- **AIR CONDITIONING—DEALER INSTALLED—FAN POWER LEAD WIRE “RELOCATION”**
- **FAN—AIR CONDITIONING—DEALER INSTALLED—RELOCATION OF POWER LEAD WIRE**
- **WIRING—AIR CONDITIONING—DEALER INSTALLED—PUSHER FAN POWER LEAD “RELOCATION”**

**Article No.
91-24-9**

MERCURY: 1991 CAPRI

Figure 1 - Article 91-24-9

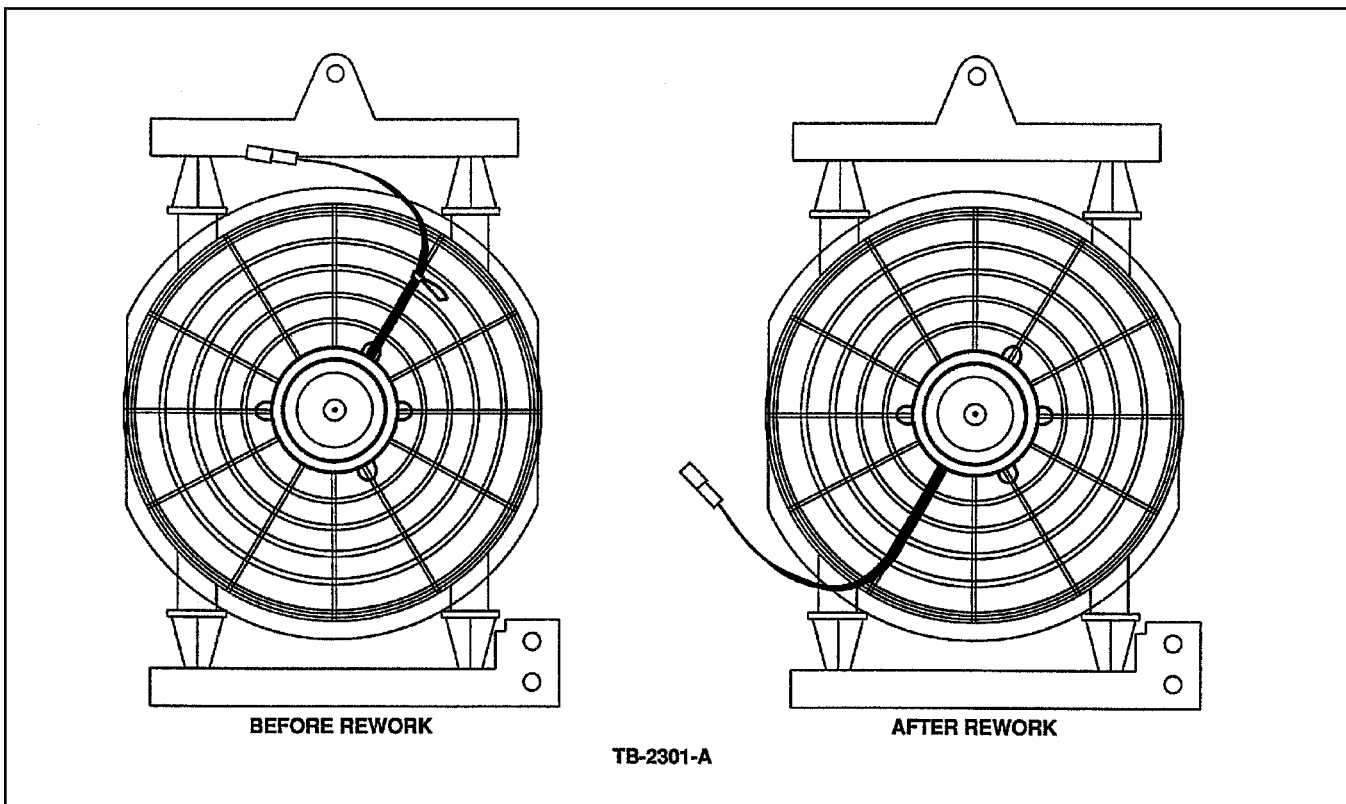
Dealer installed air conditioning kits purchased before 5/31/91 contained pusher fans with the power lead in the 1 o'clock position. In this position the fan motor may fill with water.

Relocation of the power lead to the 7 o'clock position will be necessary to ensure that the fan motor will not fill with water. Relocation can be obtained by removing and repositioning the fan or by replacing the fan with a new fan with the wires in the 7 o'clock position. Refer to the following procedure for service details.

1. Cut the cable tie holding the fan motor leads in place and discard the cable tie.
2. Remove the (2) bolts securing the motor to the fan shroud.
3. Rotate the motor 180 degrees so that the leads are in the 7 o'clock position. Refer to Figure 1.
4. Replace the (2) bolts securing the motor to the fan.
5. Manually spin the fan blades to insure that the motor does not contact the shroud.

9. Replace the fan if it is inoperative. If the fan was operational rework the fan by;
 - a. Clipping the cable tie holding the leads to the fan shroud and discard.
 - b. Remove the bolts (2) that hold the fan to the shroud, save the (2) screws for reinstallation.
 - c. Rotate the fan motor 180 degrees so that the motor leads are in the 7 o'clock position, Refer to Figure 1.
 - d. Replace the (2) bolts securing the motor to the shroud.
